LOS ALAMOS NATIONAL LABORATORY
ENVIRONMENTAL RESTORATION
Records Processing Facility
ER Record Index Form
RPF USE ONLY

THIS IS NOT AN EXCAVATION PERMIT
LANL CONSTRUCTION/MAINTENANCE/SWMU SCREENING REVIEW
LABORATORY PROJECT REVIEW TEAM

LANL Construction Project No: _____ Project Title: CLEAN UP OF SWMU #3-001(i)

Voluntary Corrective Action Plan for
PRSs 3-001(i), Former Equipment Storage Area
OU 1114, Field Unit 1

Fig. TA-3-70-1. Former equipment storage area, PRS 3-001(i).

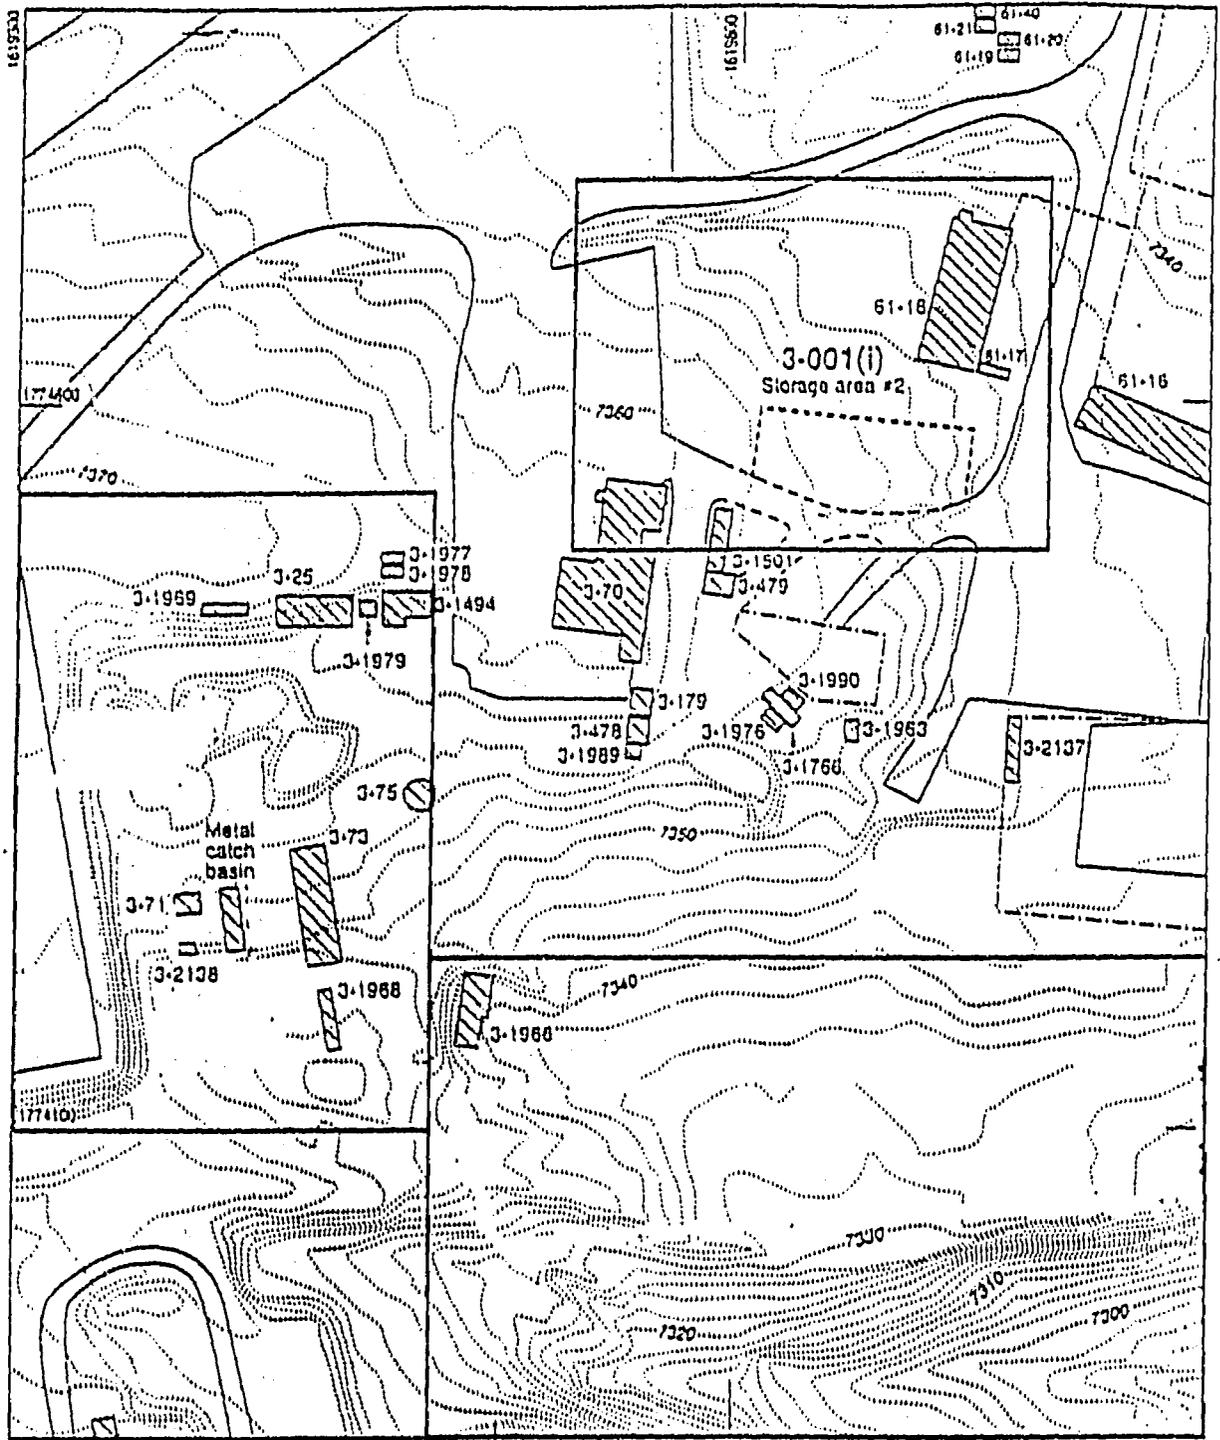
This project involves the Voluntary Corrective Action Plan for ER listed site #3-001(i). This site is a former equipment storage area, that is located northeast of building 70, which is located in TA-3 (reference attached map).
